Subject: Site Plan (Development & Design Review) - Parcel IDs: 2434-801-0005-010-6 & 2434-801-0004-000-6 – Technical Review Committee Comments for August 17, 2023 TRC Meeting

RE: **Site Plan (Affordable Housing) - 23-07000018**
Parcel IDs: 2434-801-0005-010-6 & 2434-801-0004-000-6

Re: Sound Meadows Minor Site Plan – Comment Response Letter #1
Our Reference Number: 22-065

SP 2

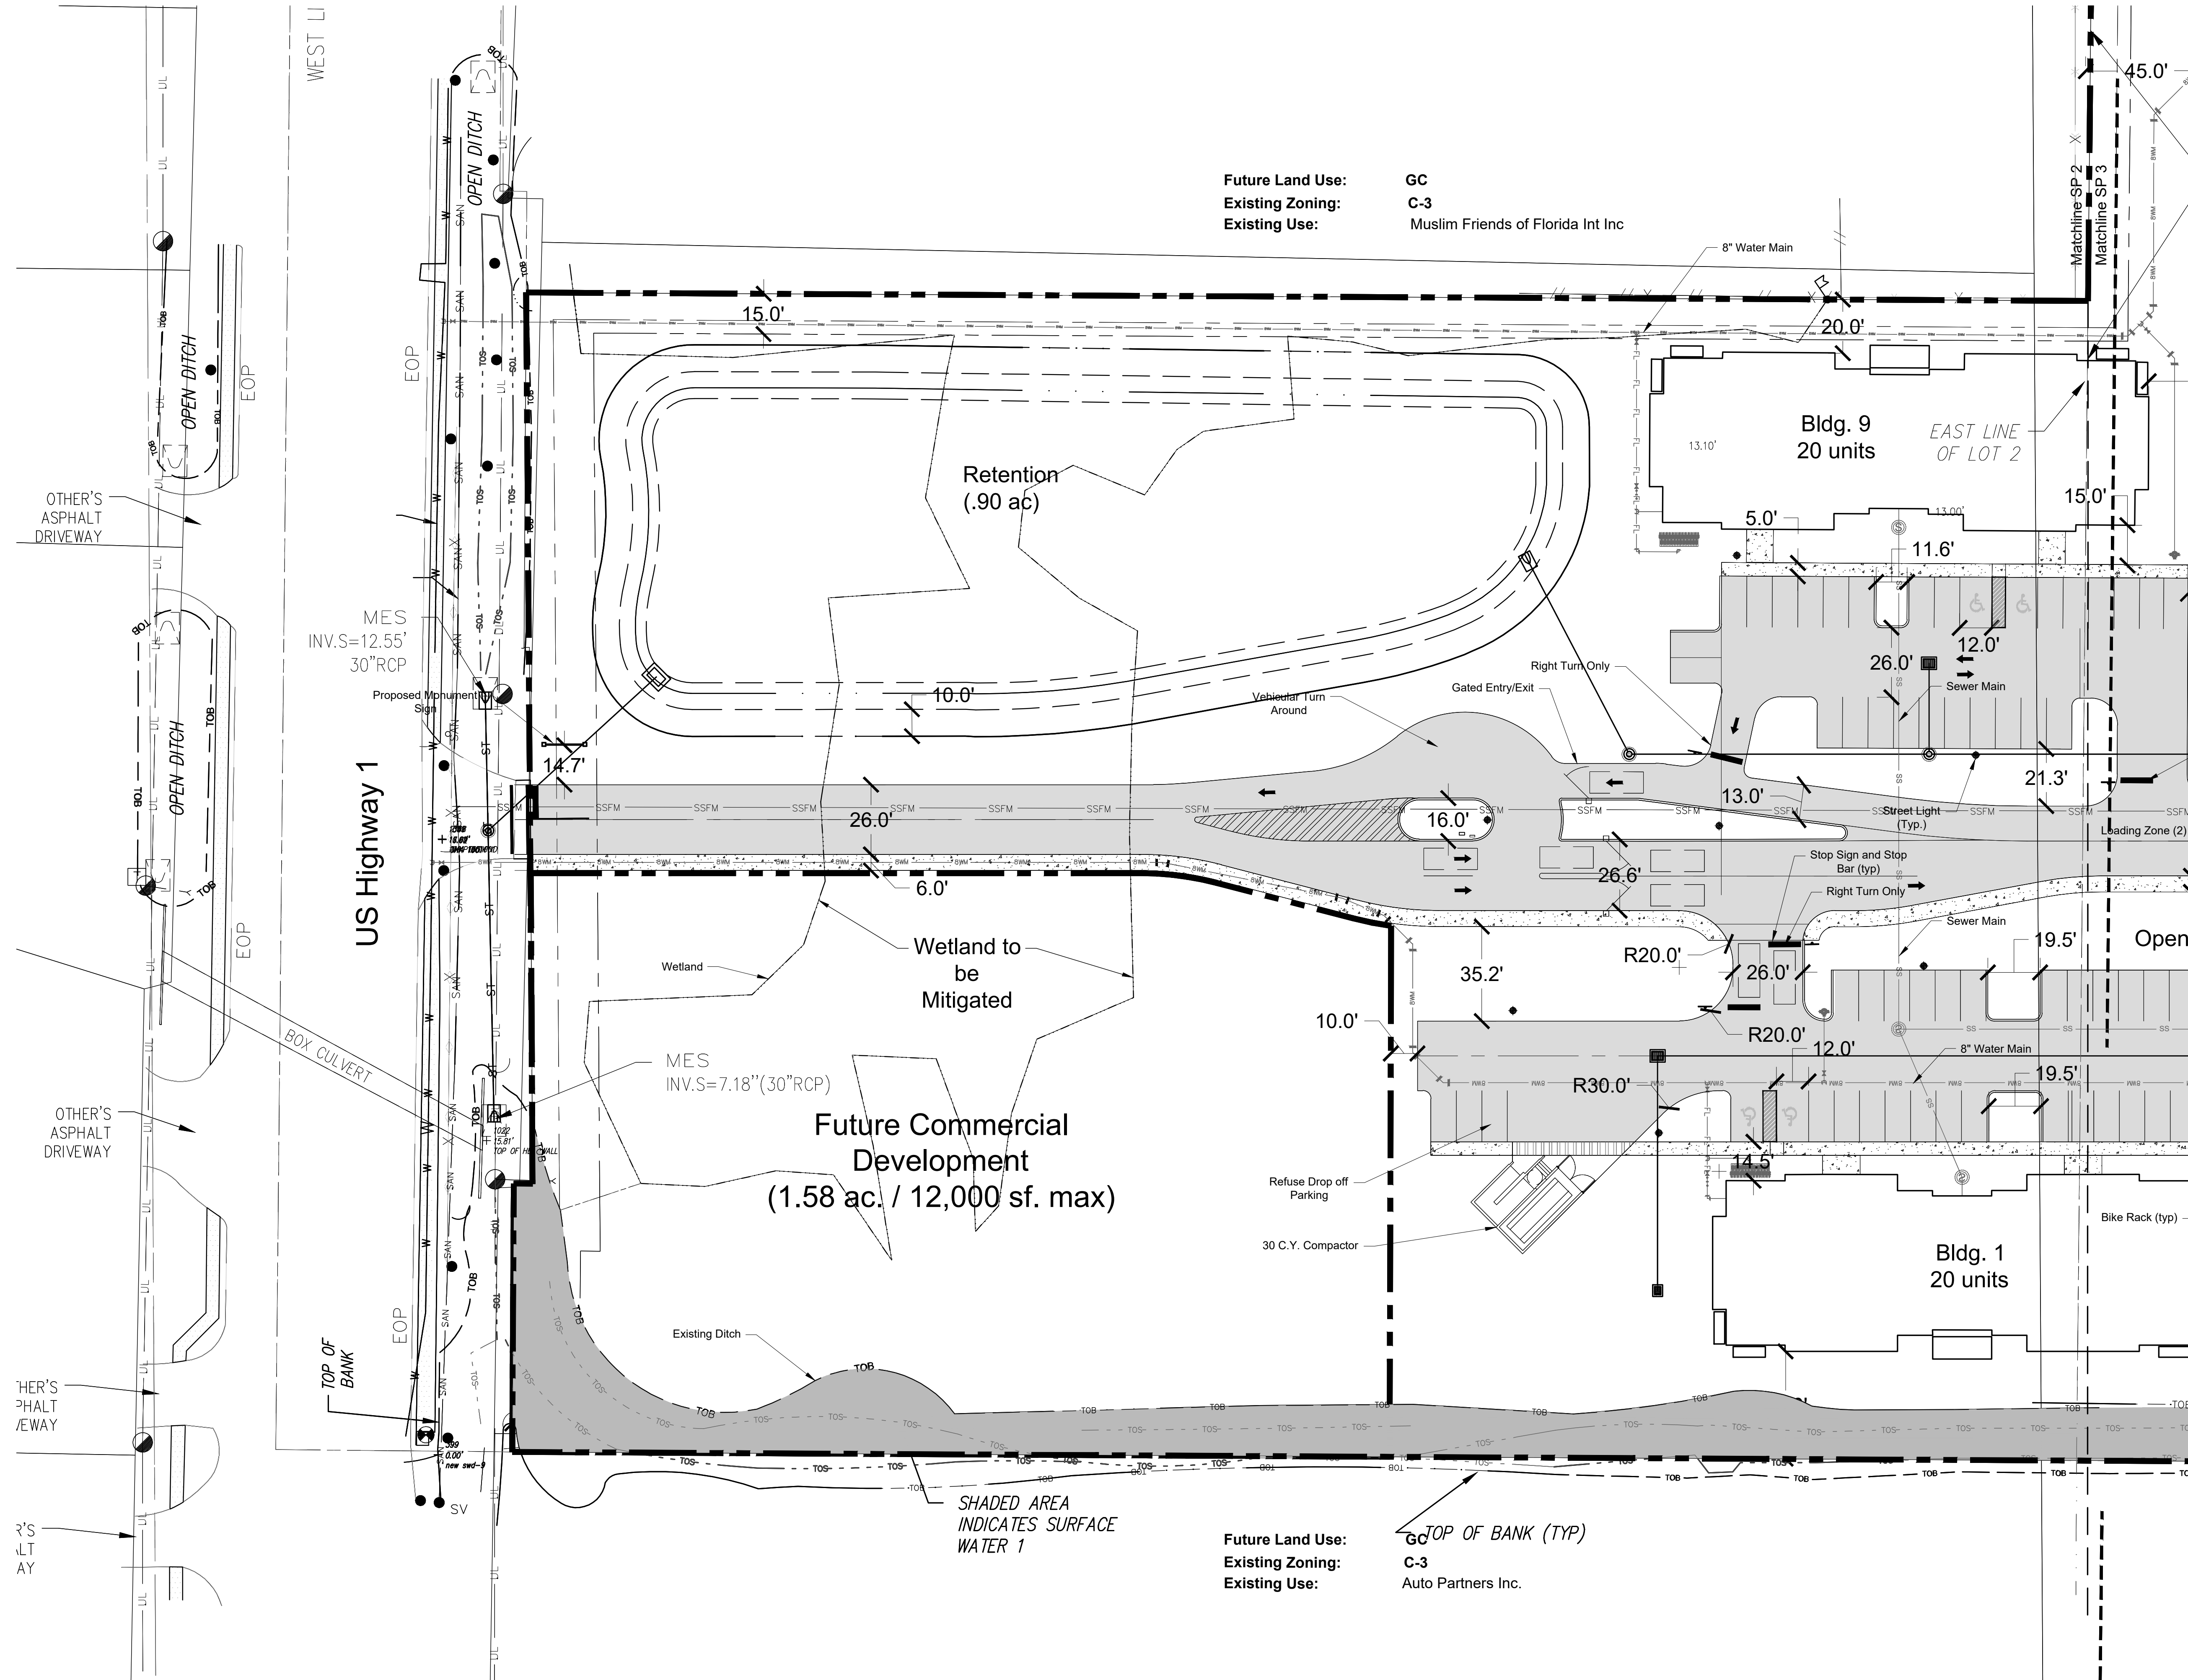
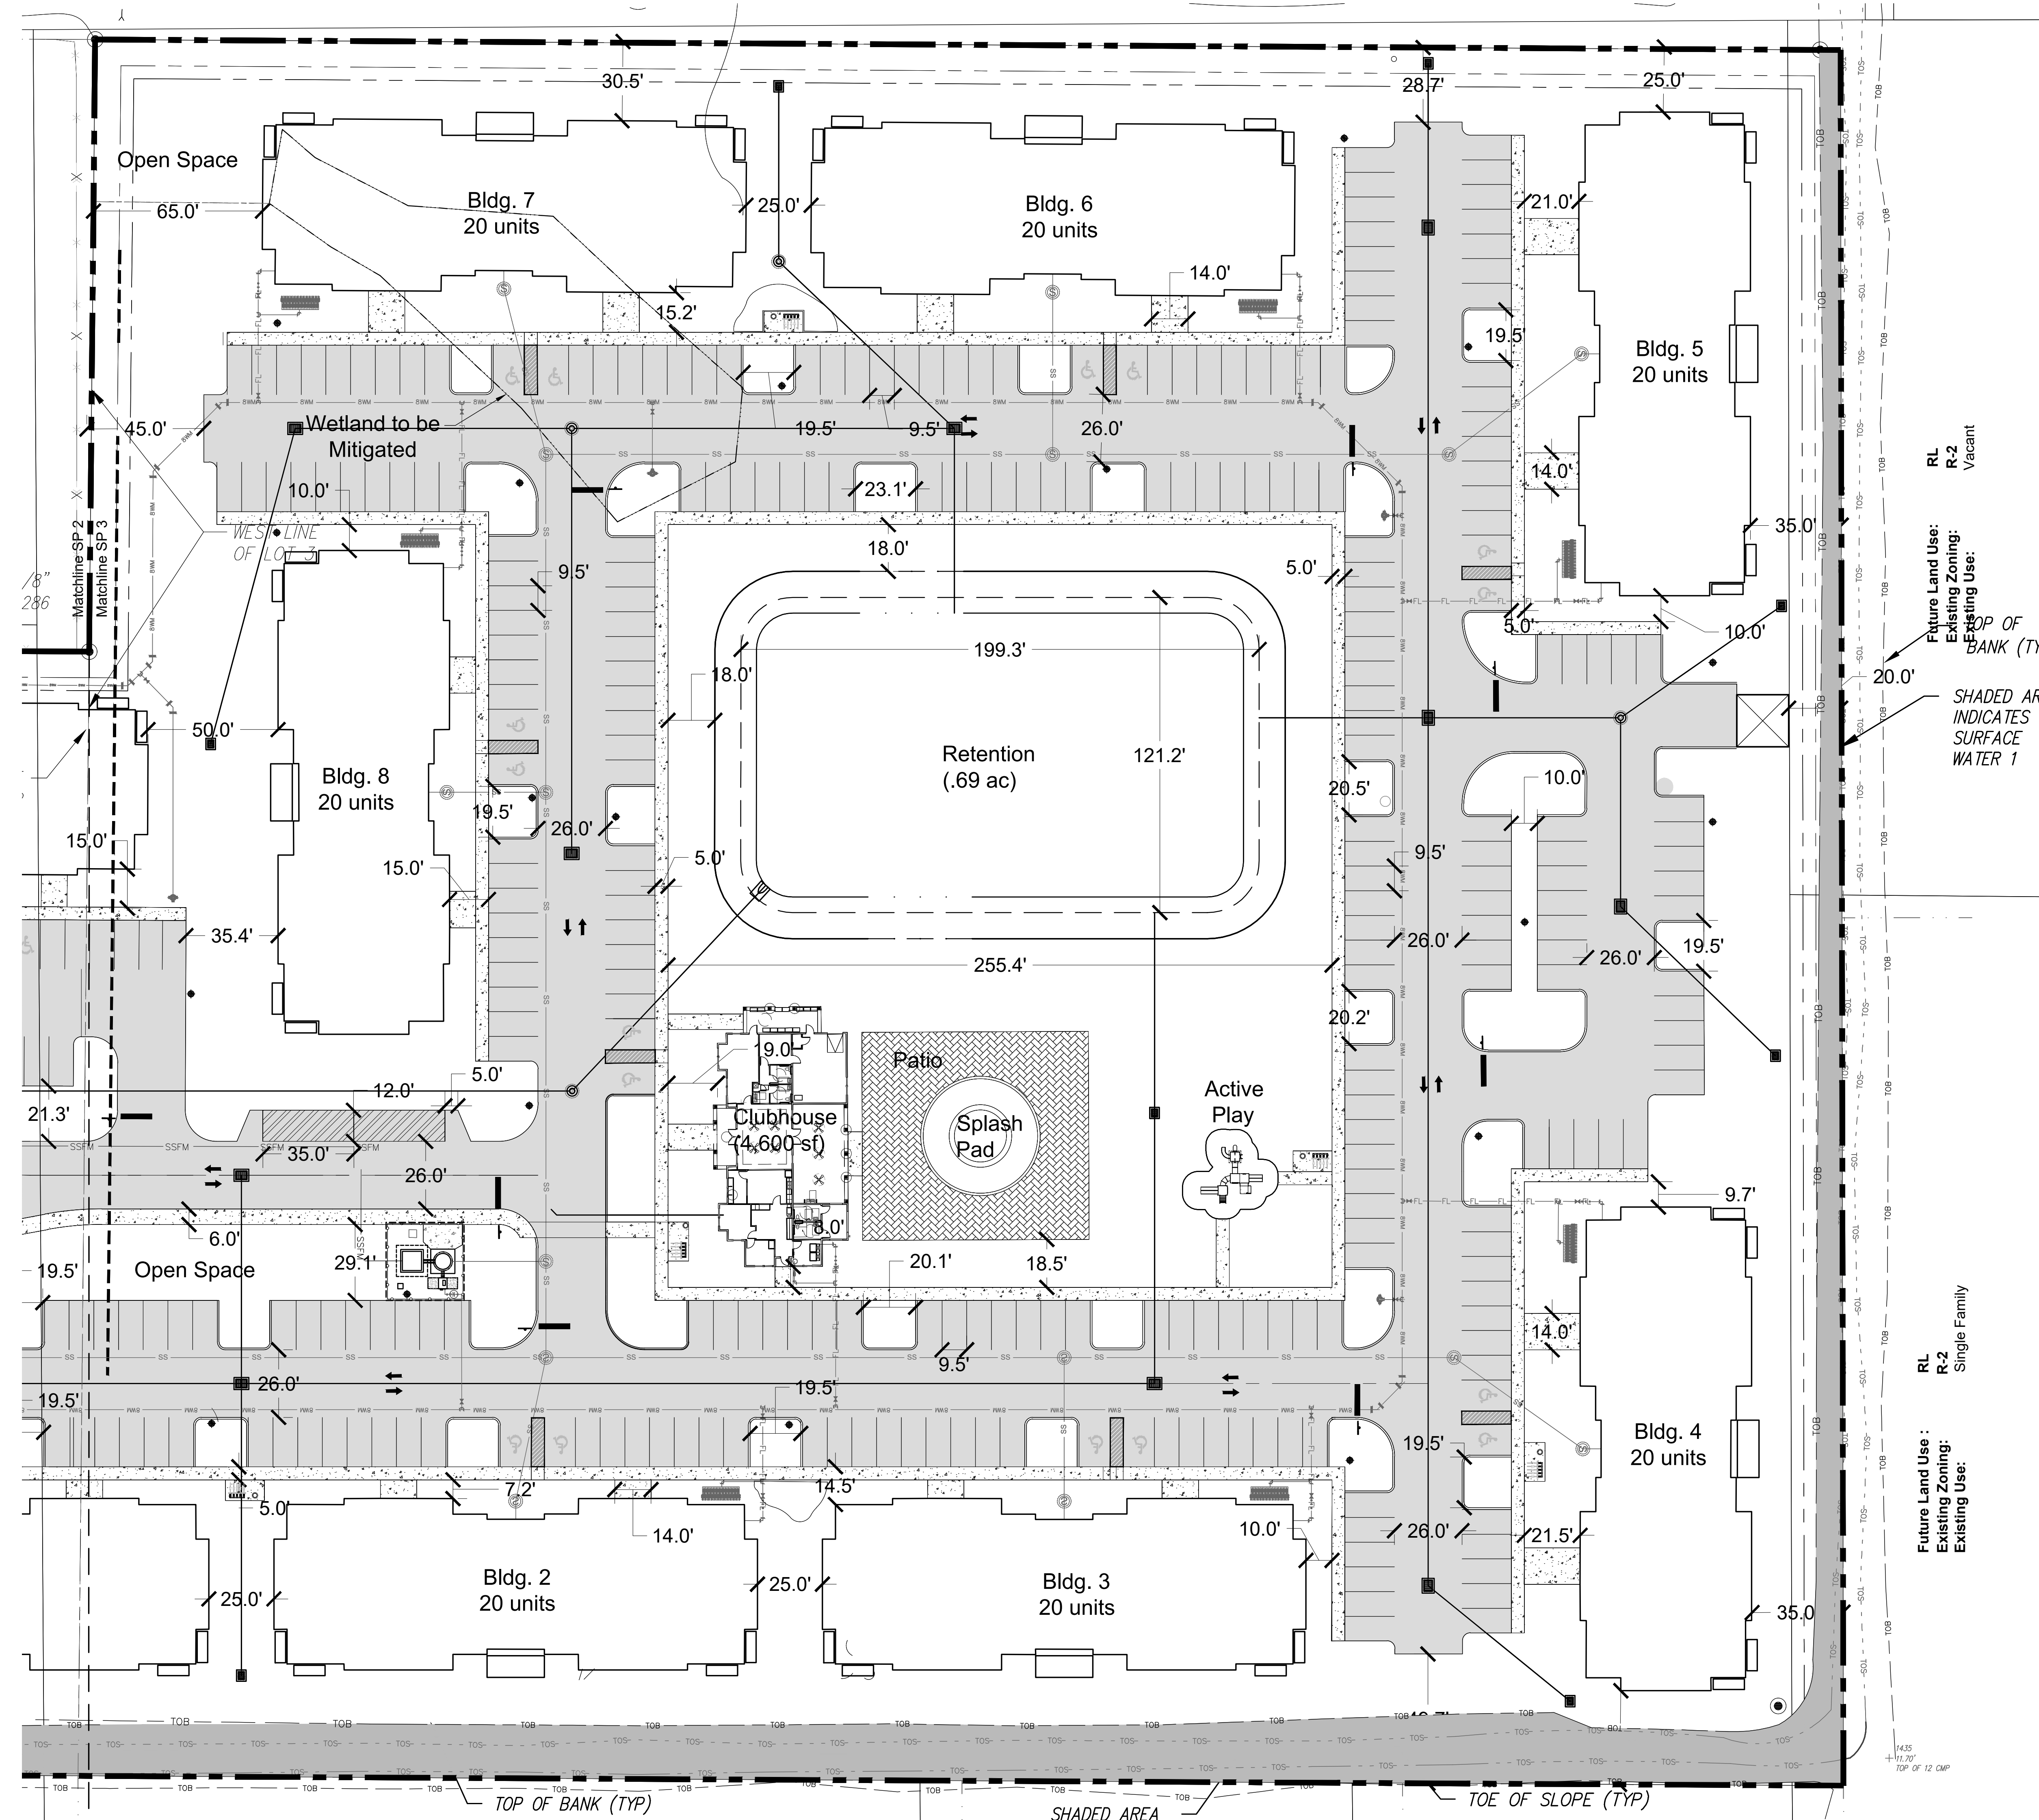
2. Stop signs, stop bars, and directional arrow striping will need to be placed in proper intersection locations throughout the property. Please Identify on Site Plan.

Response: Acknowledged; all proposed striping, as included on the Civil Engineer's Preliminary Civil Engineering Plans, are shown on the revised Site Plan.

Designer	SAW	Sheet
Manager	BN	MT-3
Project Number	22-065	
Municipal Number	---	
Computer File	22-065_SoundMeadows_SitePlan.dwg

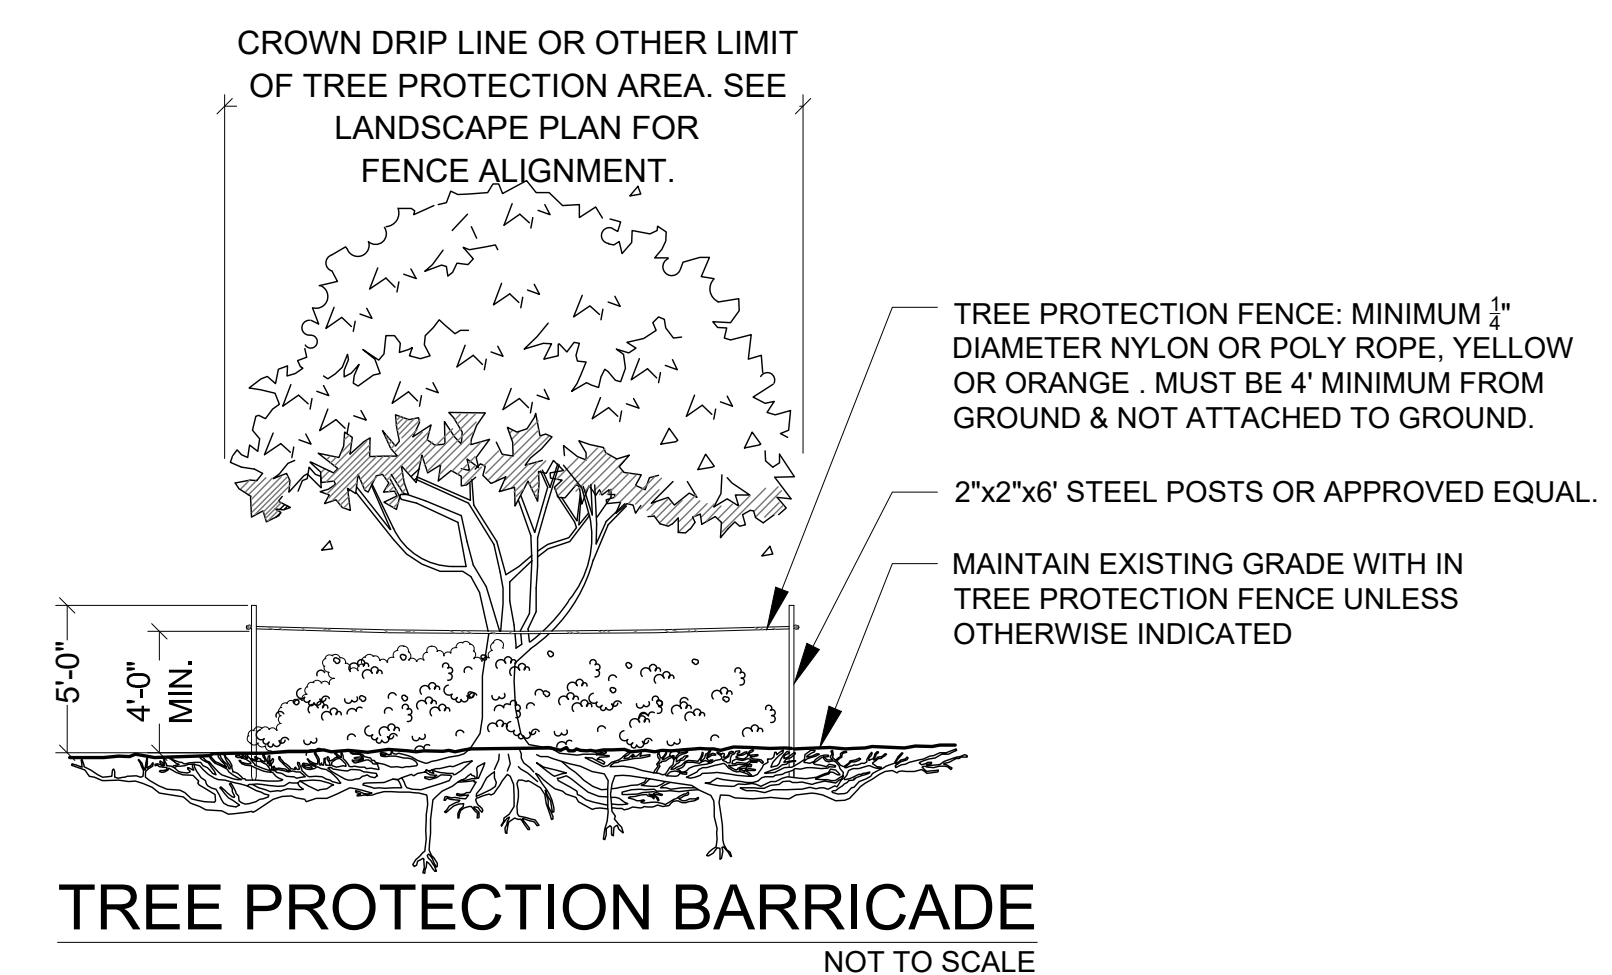
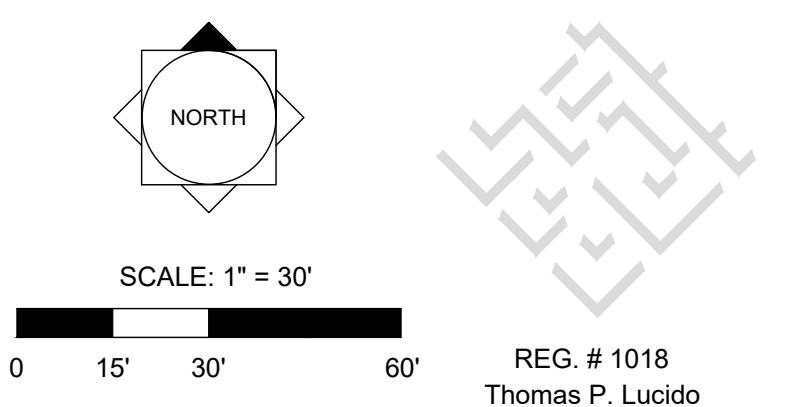
4. Provide the Tree Survey in reference to the Tree Mitigation Plan Sheet MT-3.

Response: The submitted ALTA Survey includes locations of existing native trees.
